**JOINT ARCHITECTURAL BOARD/PLAN COMMISSION AGENDA**  
**MONDAY, JANUARY 15, 2018**  
**7:00 PM**  
**BOARD ROOM**  
**MUNICIPAL BUILDING, 210 COTTONWOOD AVE.**

Re: Village of Hartland  
Austin Plumbing – Plan Review Letter

The Village of Hartland's Staff as well as Ruekert & Mielke, Inc. has reviewed your site plan submittal. The submittal included the following: sheets C1.0, EX1.0, A1.0, A2.0 and A3.0 all dated November 3, 2017; site grading and drainage plan sheet C100 dated December 26, 2017; and lighting plan dated December 27, 2017. In addition, draft storm water calculations were sent via email by Mark Ellena on December 26, 2017. We are providing the following comments as guidance and direction for your design staff in preparation of for the next Plan Commission meeting and for final documents. **Please respond to the comments below, in writing, with your next submittal.**

**SHEET:**  
**C1.0**

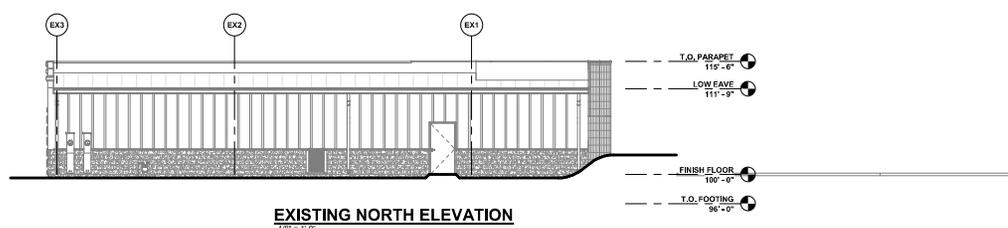
1. Add sheets C100 and the lighting plan to the index.
2. Provide the names and contact info for the plan Designers and Owner.

**SHEET:** **A2.0**

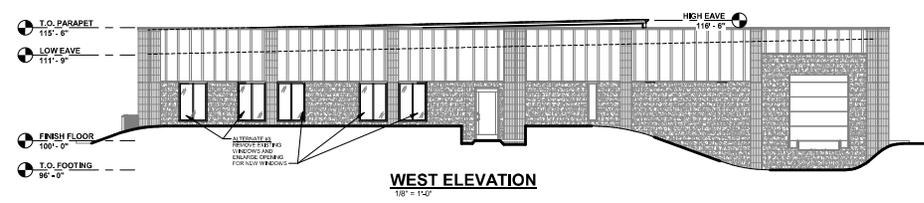
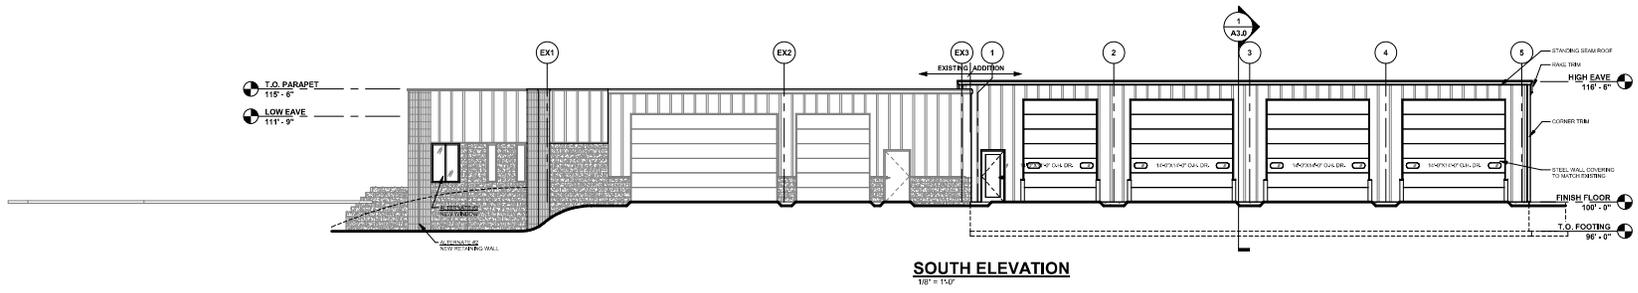
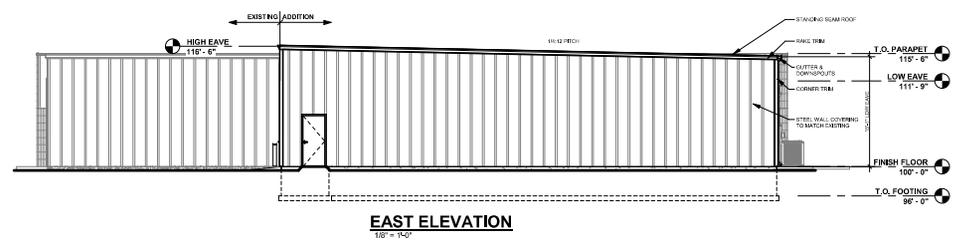
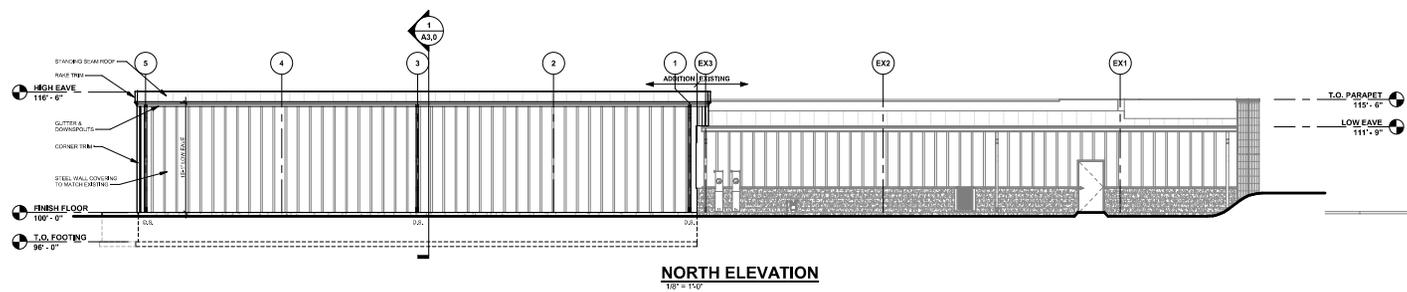
1. Add West and South elevation views for the Alternate #2 retaining wall and Alternate #3 window configuration.
2. Are there any roof top mechanicals or ground mechanicals? Show them on the drawings.
3. Existing north, west and south building elevations include a “belt” of CMU with metal siding above. Proposed addition specifies metal siding only. The Village’s expectation is that the proposed addition includes similar wall treatment for north, west and south building elevations.
4. The proposed north elevation is long and vast, without architectural or landscape features to break up or soften appearance. The Village’s expectation is for architectural features, such as windows or landscaping to be incorporated into north building elevation.

SHEET:  
C100

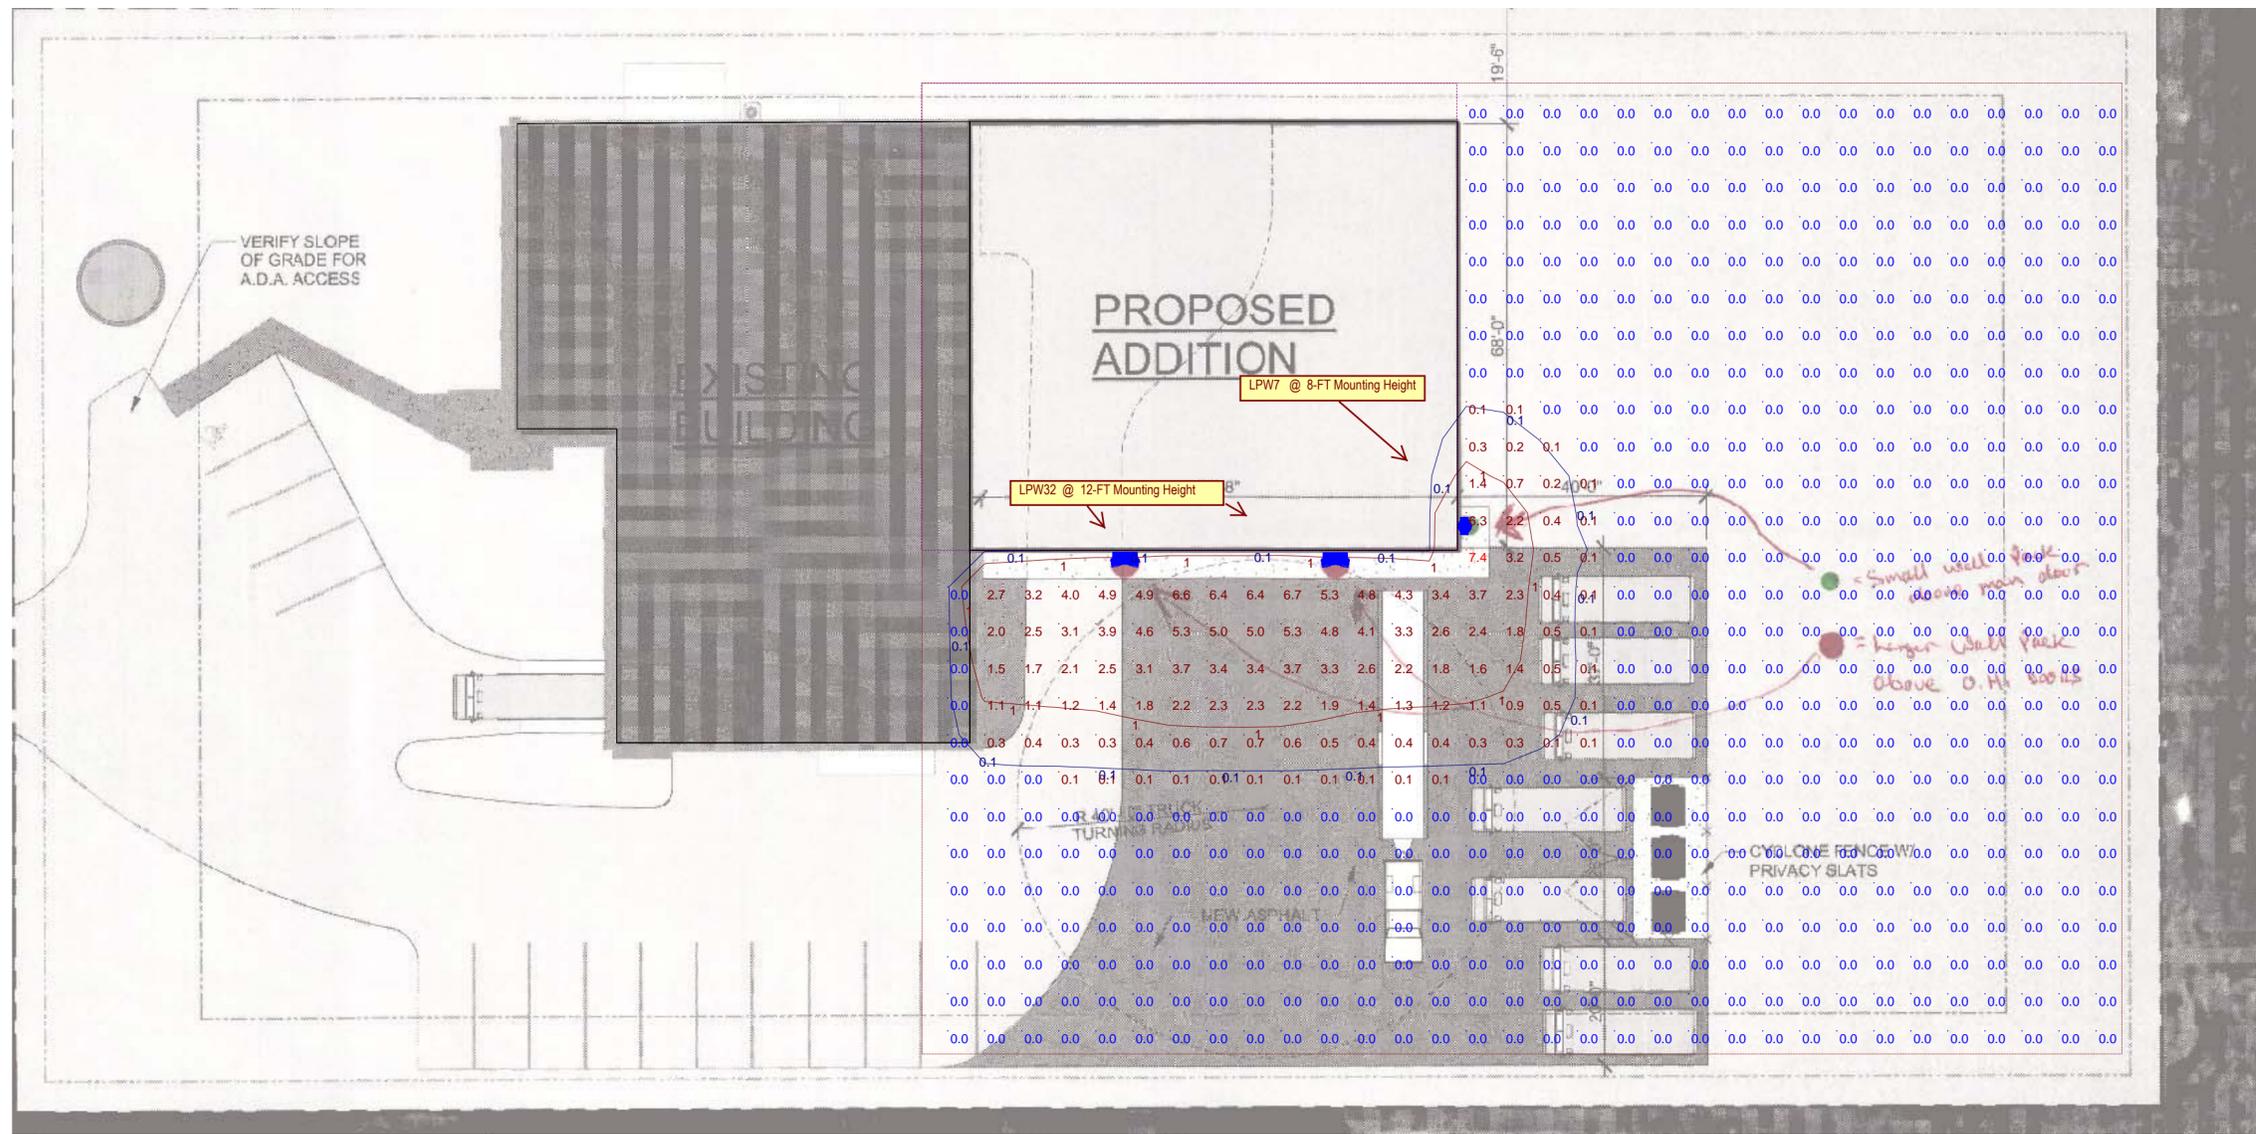
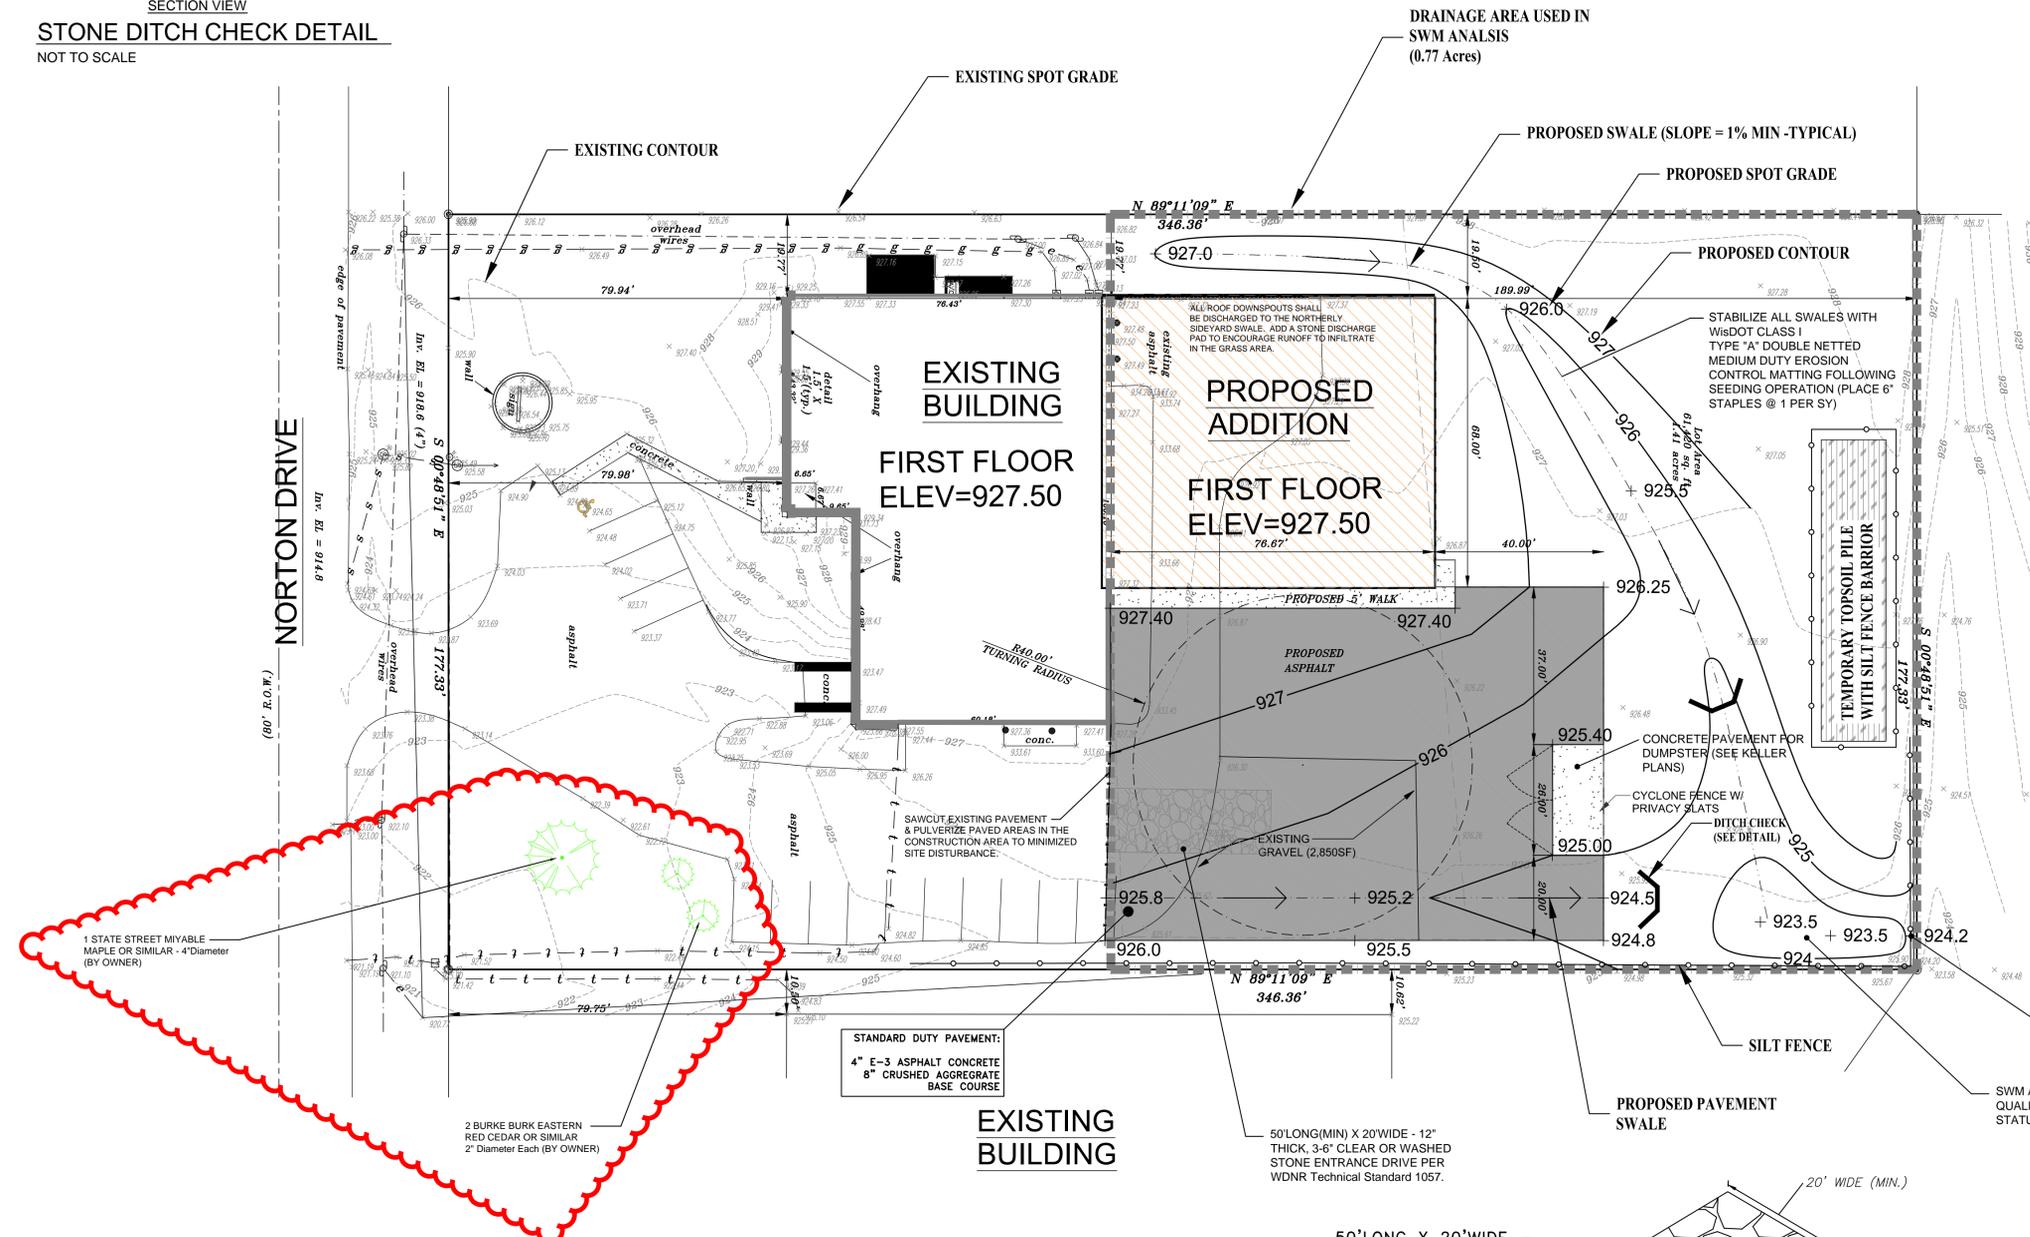
1. Provide PLS stamp on plat of survey.
2. Show the existing pine trees along the south lot line. Do they conflict with proposed swale and/or silt fence?

3. Verify that swale width and depth along southern lot line is adequate for the contributing drainage area and that the existing pine trees are not in conflict. If necessary, consider offsetting the paved parking area to the north to provide room.

4. Show sizes of proposed trees at southwest part of the site.
5. Change reference to “City” to “Village” in general construction note 7.
6. Construction Phasing Sequencing:

- a. 3. If any topsoil will be reutilized on site, show the stockpile and use perimeter silt fence.
  - b. Add 4. The proposed swales, storm water facility and initially disturbed areas shall be restored and erosion matted prior to further work. Install ditch checks in the swales.

- c. Add a number, “Sweep driveway and street as necessary or requested by the Village to keep free of debris”.
7. SWM Redevelopment Site Review:
  - a. Change reference from “TTS” to “TSS”.
